From: [REDACTED]
Sent: 21 April 2025 21:35
To: Rachel Richardson
Cc: planninginfo
Subject: Re: DM/25/0214
Attachments: 1000022938.jpg; 1000022939.jpg

I wish to make an objection to the above planning application on the following grounds:

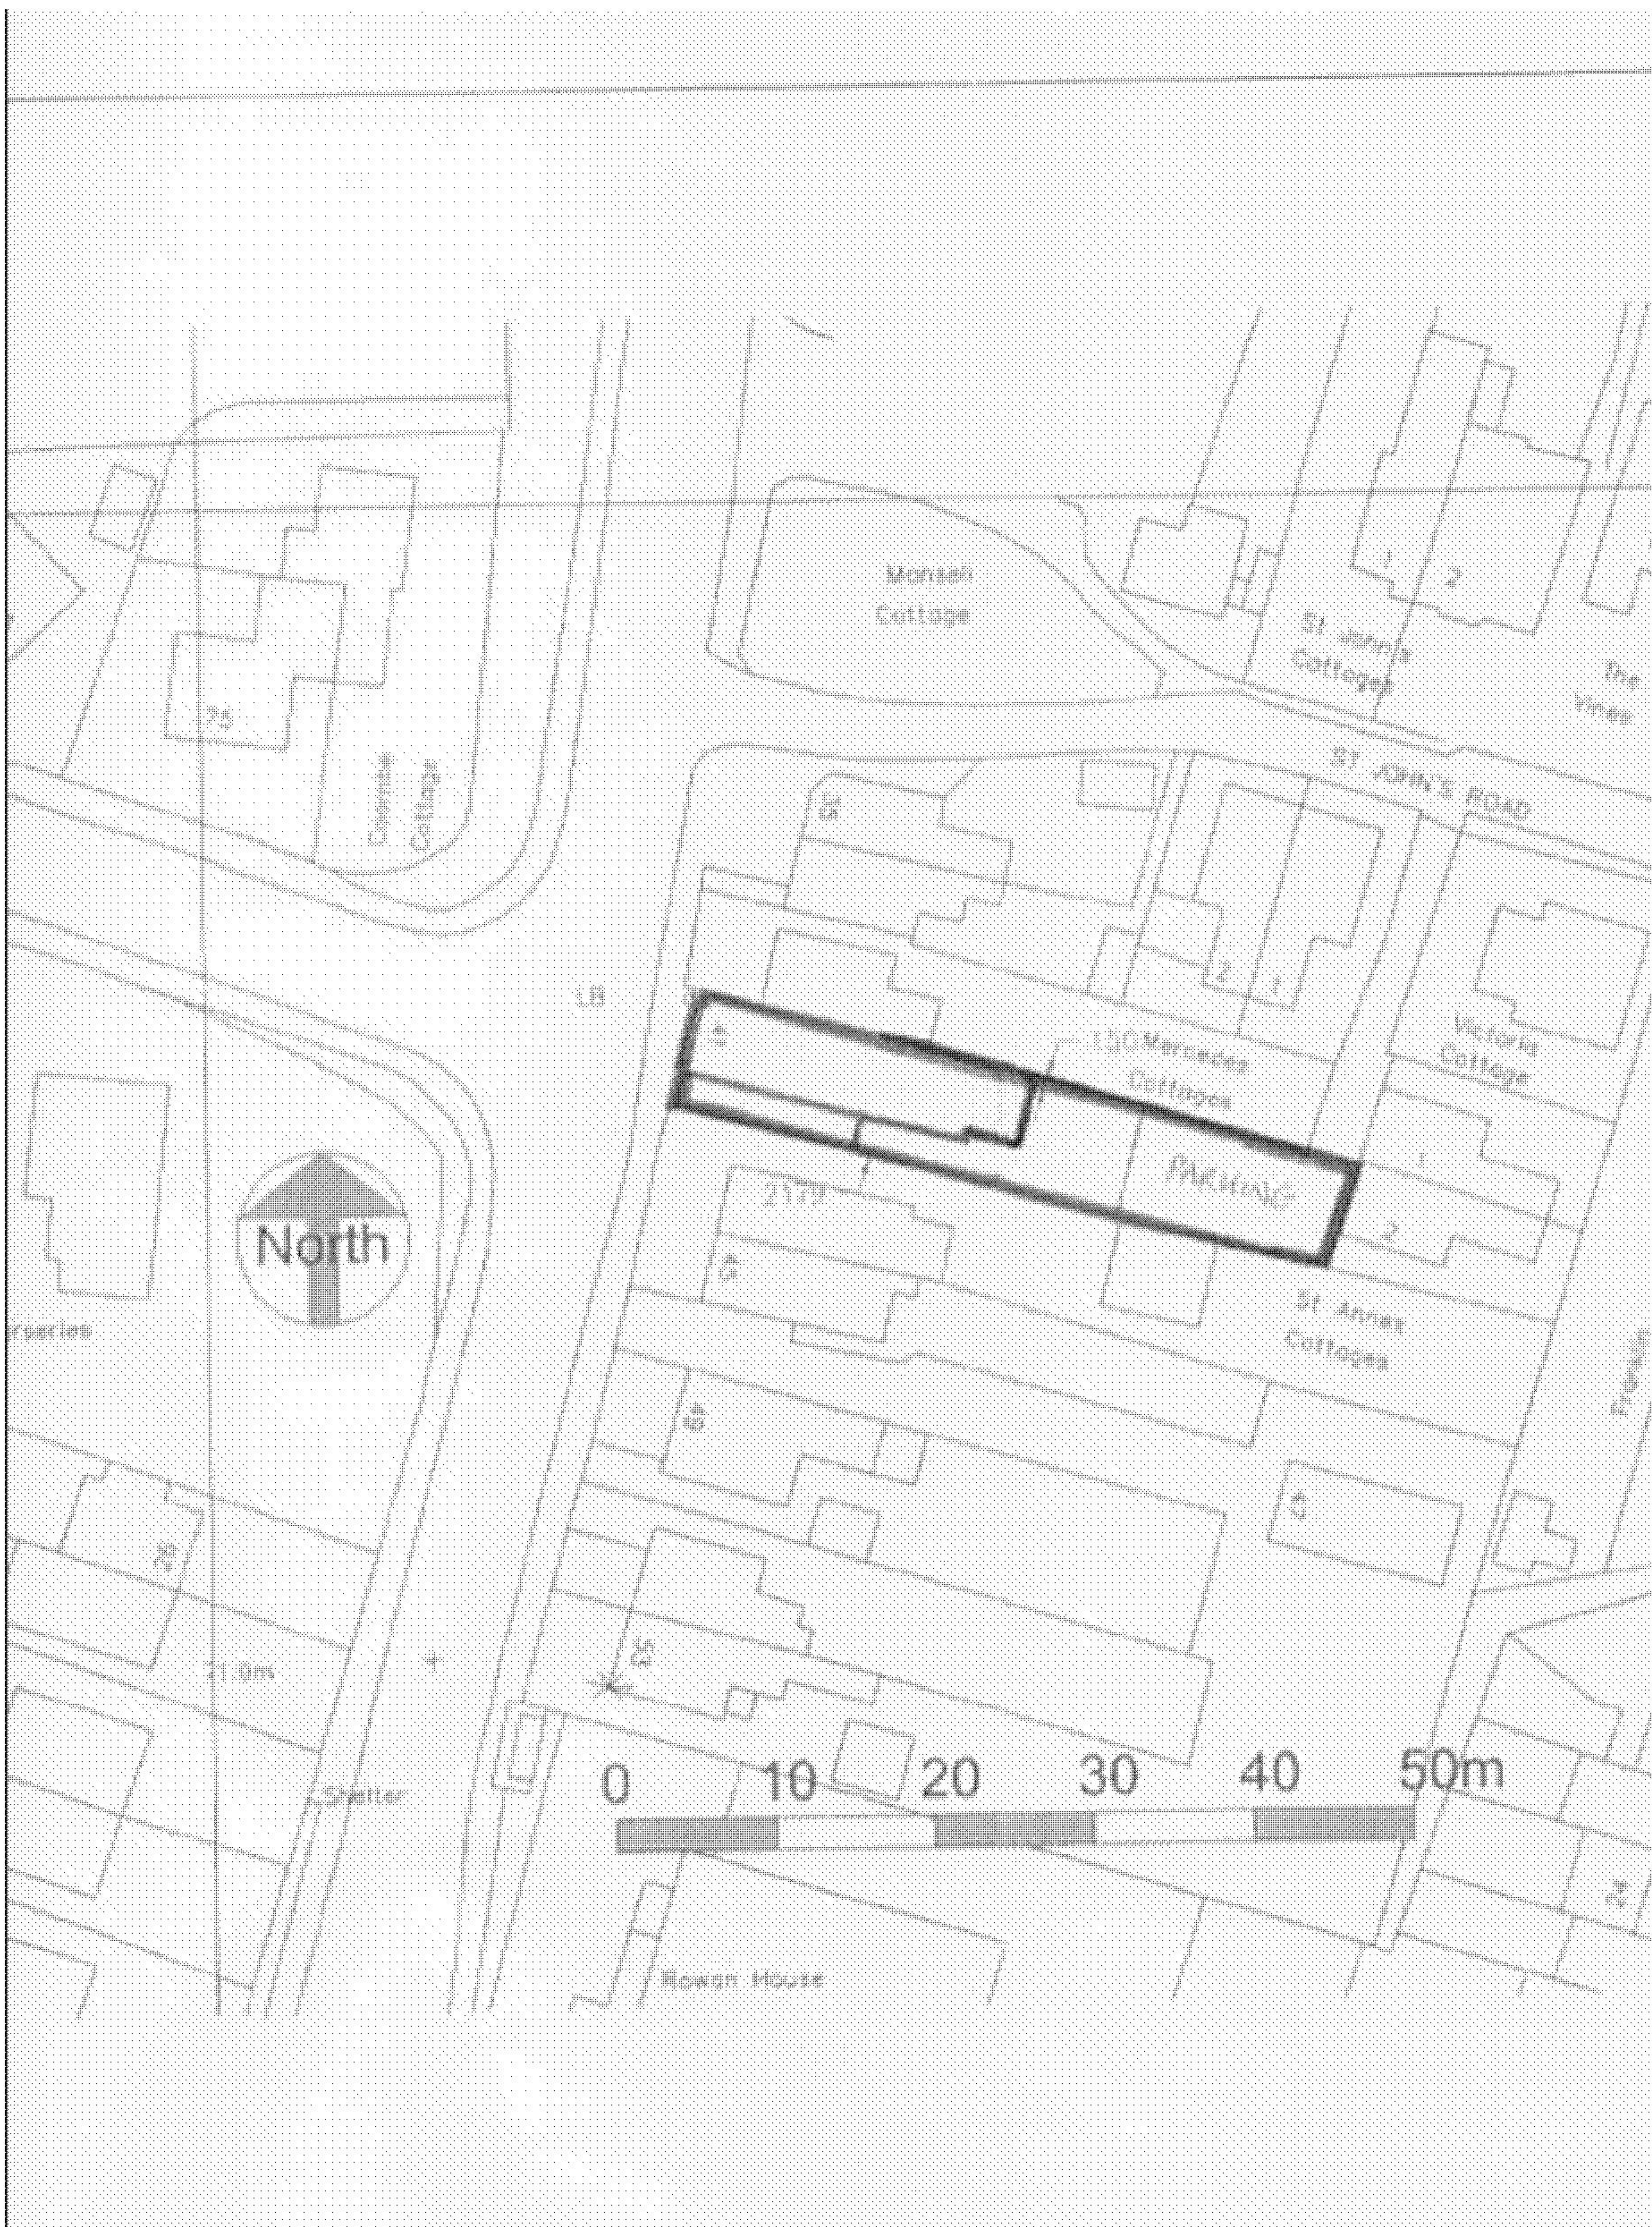
- 1) Safe Access: The plans show a driveway which is straight. This is not the case there is a kink in the driveway.

None of the plans would appear to show how the fence cuts in, nor the drain pipes or guttering / drainage which leave a very small gap to access through. None of the plans show the actual dimensions of the driveway which is 2.1m at its narrowest, which is far too narrow for a driveway with regular access and the council should be concerned to note that none of the plans actually show dimensions.

In red below you will note where the second carparking space for 43 Wivelsfield Road is proposed. This area is at a substantial incline of 1.8m height increase over 6.5m, and will involve a considerable amount of soil removal, retained wall to support the neighbours garden at 45 alongside soil . The plans indicate the vehicles will presumably reverse through a completely inadequate, with inadequate turning for any motor vehicle according to plans.

The plans do not indicate how they will deal with camber of the driveway rising up the drive but allowing the carpark to the rear reversing down a driveway of 2.1m a near impossibility without car or building damage. You will see from the photos the driveway is at quite a steep slope and this needs to be thought through much more considered way as is completely inappropriate.
